SI B41 01 16
Body

Recall Campaign 16V-XXX: ISOFIX Child Restraint System Anchors

F25 (X3)

F26 (X4)

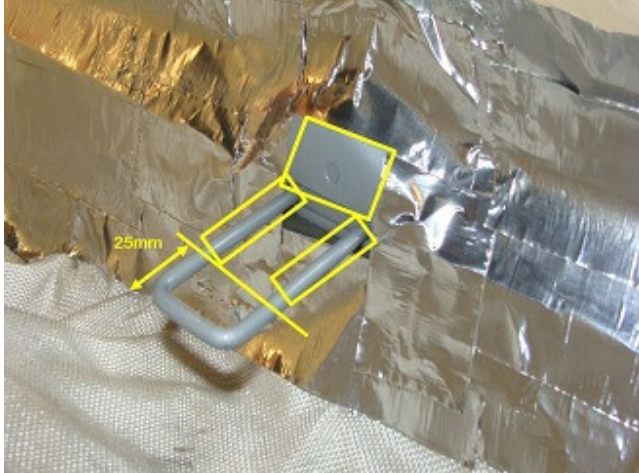
7. Cover rear luggage compartment floor with welding blanket or spark deflection paper (3M).

Note: It is imperative that the interior of the vehicle is NOT damaged by sparks or welding spatter during this process.

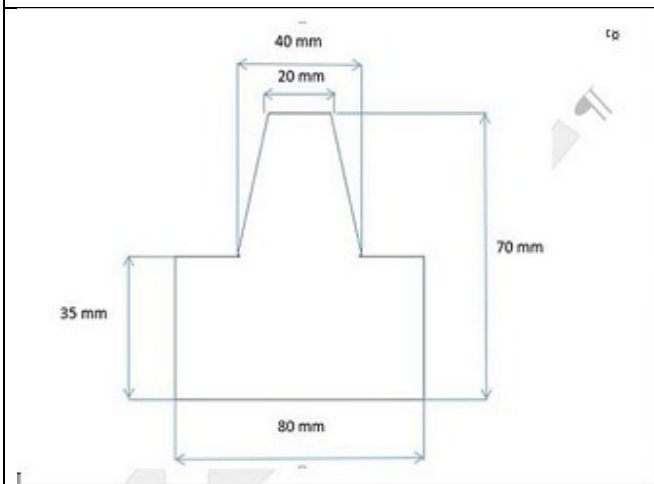
15. First, weld the left side of the bracket, progress to the top of the bracket as shown. Then continue to weld the left side of the remaining brackets as to allow time to cool.

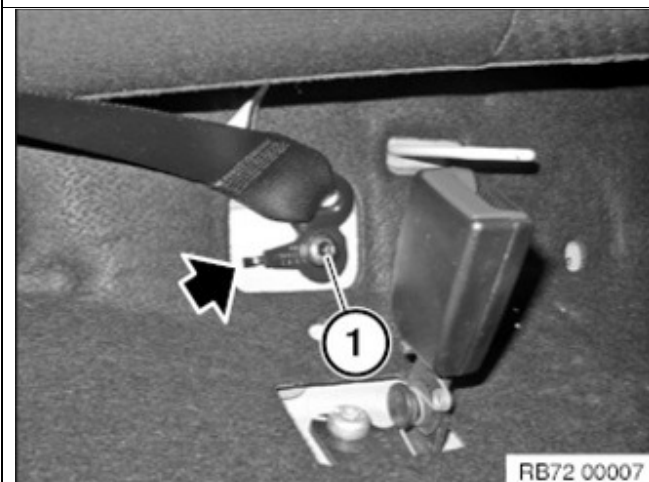
22. After anti-corrosion protection has dried sufficiently, install felt pads.
